**Report: PUNCHLIST**  
**Function: Test, Adjust, & Balance**  
**Date: 03/10/2026**  
**Completed By: National TAB**

**PROJECT**  
**03-09-26 QT #0588 OMAHA, NE**

QUIKTRIP  
4705 SOUTH 129TH EAST AVENUE  
TULSA, OK 74134

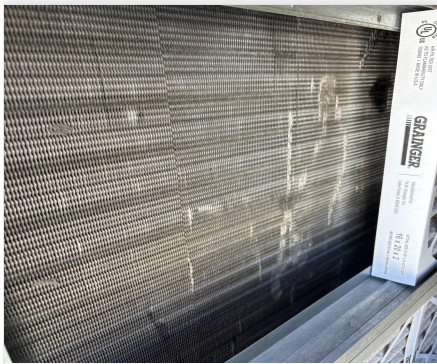
**Issue Name :** EF-2: Air Leakage  
**Description :** There is air leakage at the base of EF2. The inlet of the fan slightly overhangs the curb cap. This is affecting fan performance and efficiency. Recommend reworking curb or installing new curb cap to properly seal fan base.  
**Created By :** National TAB                      **Assigned To :** National TAB - Dan Hertenstein  
**Status :** Open  
**Priority :** High                                      **Asset Tag :** EF2  
**Originated Date :** 03/10/2026 - Kalen Kemp - National TAB

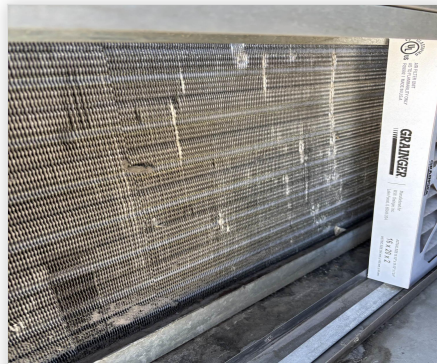
**Issue Name :** RT-1: Coil  
**Description :** The evaporator coil for RT-1 has minor damage.  
**Created By :** National TAB                      **Assigned To :** National TAB - Dan Hertenstein  
**Status :** Open  
**Priority :** Low                                      **Asset Tag :** RT-1  
**Originated Date :** 03/10/2026 - Kalen Kemp - National TAB
